M E M O R A N D U M

To: City of Whitewater Plan and Architectural Review Commission
 From: Chris Munz-Pritchard City Planner
 Date: September 9, 2019
 Re: **Item # 4** Proposed adding new residential units at 136 W Main Street Whitewater WI, Tax ID# /OT 00003 for Urim Shabani.

Summary of Request	
Requested Approvals:	Adding new residential units
Location:	136 W Main Street, Tax ID# /OT 00003
Current Land Use:	B-2 Central Business

Main Floor (First Floor). The proposal a space designed for a coffee shop in the front of the building, with four office / retail spaces located down a corridor behind the coffee shop area. Per 19.30.030 (G) (1) First floor residential uses are prohibited in any building located in this area.

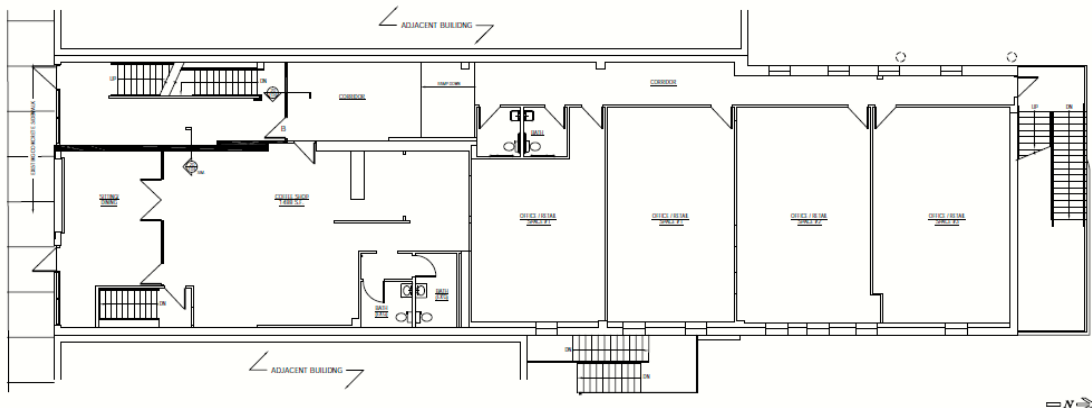
If the coffee area wants outdoor seating it will need to apply for a sidewalk café permit and follow the guidelines in 5.19.060 of the city code. In the event that the coffee area wants to serve alcohol beverage it will need to follow 5.19.070 of the city code.

Second Floor The proposal on the second floor is for 5 residential units. Each unit is a one bedroom. Three of the units are in the existing building. The other two units are new construction on the second floor.

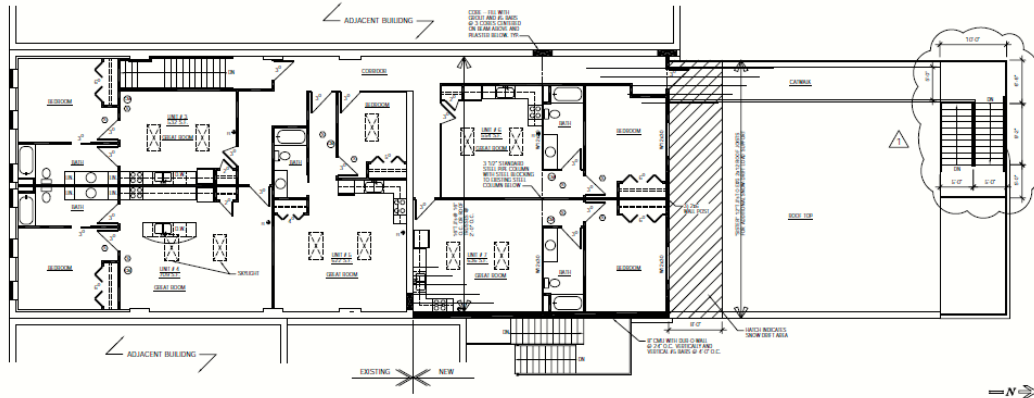
This area does have a large open roof top that would be ideal for an outdoor area for the apartments to utilize. I would urge you to consider this in the design. If not for the 5 units on the second floor, maybe just for units 6 and unit 7. These could be walk out areas from the bedrooms.

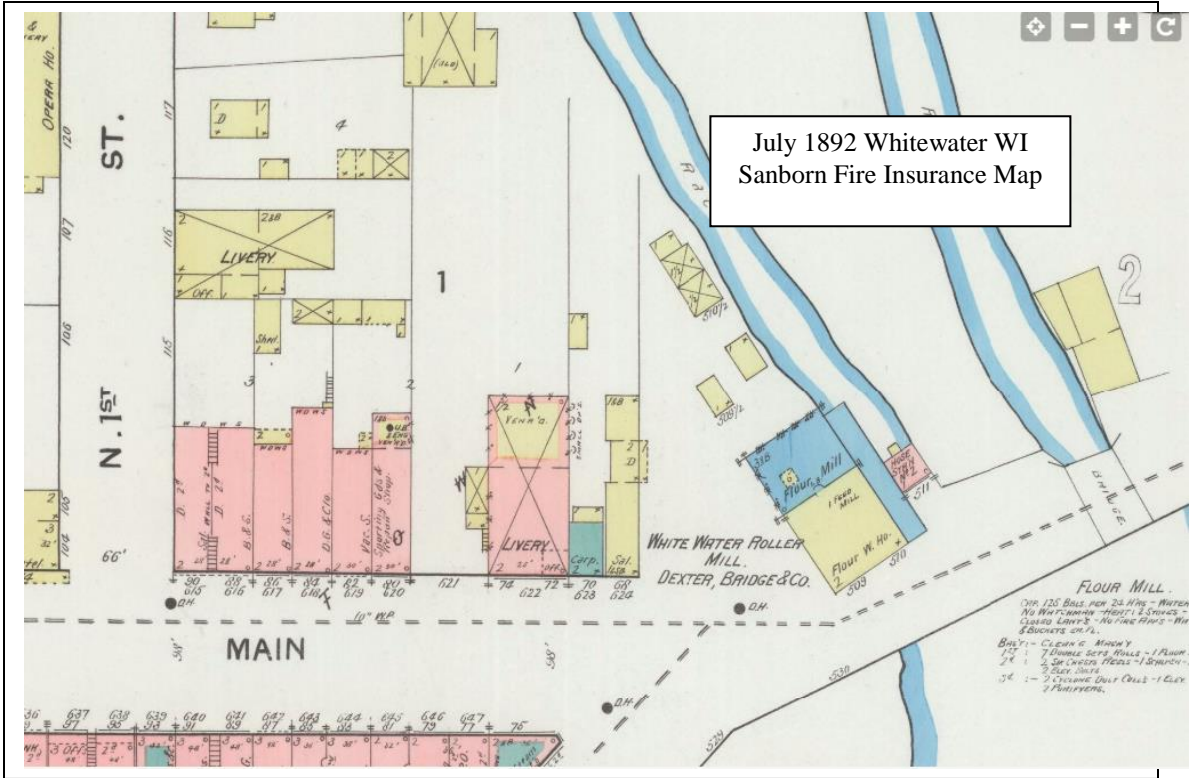
Walls separating dwelling units and corridor walls will have fire partitions. Parking is not required in the B-2. Parking permits for the downtown area are good from June 1 through May 31 will be available for sale at the Whitewater Police Department lobby window.
